**HISTORIC PRESERVATION REVIEW BOARD  
STAFF REPORT AND RECOMMENDATION**

Landmark/District: **Georgetown Historic District** (x) Agenda  
Address: **1051/1055 29<sup>th</sup> Street NW (West Heating Plant)**

Meeting Date: **November 2/December 21, 2017**  
Case Number: **17-633** (x) Demolition

The heating plant's steel framing shown while under construction.

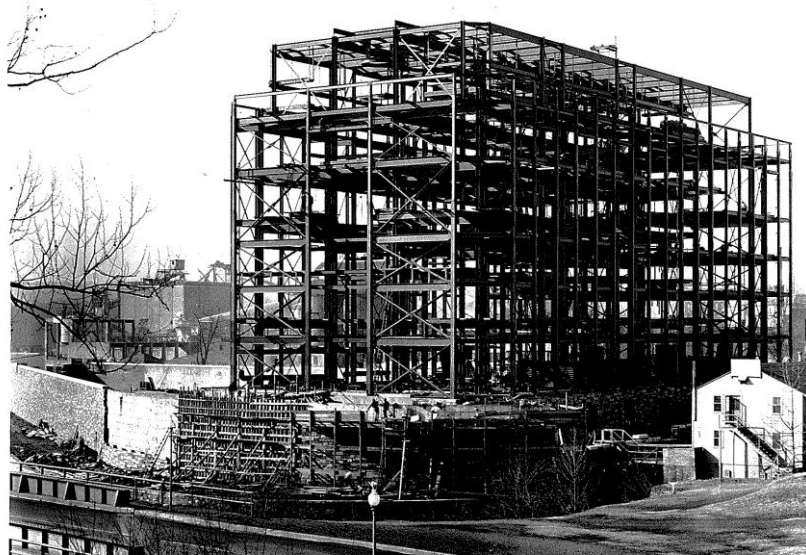
Structural engineering reports do not conclude that the building is near collapse.<sup>3</sup> In evaluating the steel structure (photograph above), the engineers note the presence of rust scale at the base of the cavity in which the steel stands. It is not unusual for steel to rust when exposed to moisture, but the reports do not cite significant loss of bearing capacity as the major concern. Instead, inadequate lateral bracing, the effect of rust jacking on the brick walls, and inadequate structural capacity to support a new floor structure are among the issues cited. The reports discuss ways that these conditions could be addressed by appropriate repairs, reinforcement, improved moisture control, and insertion of new structural elements as part of rehabilitation.
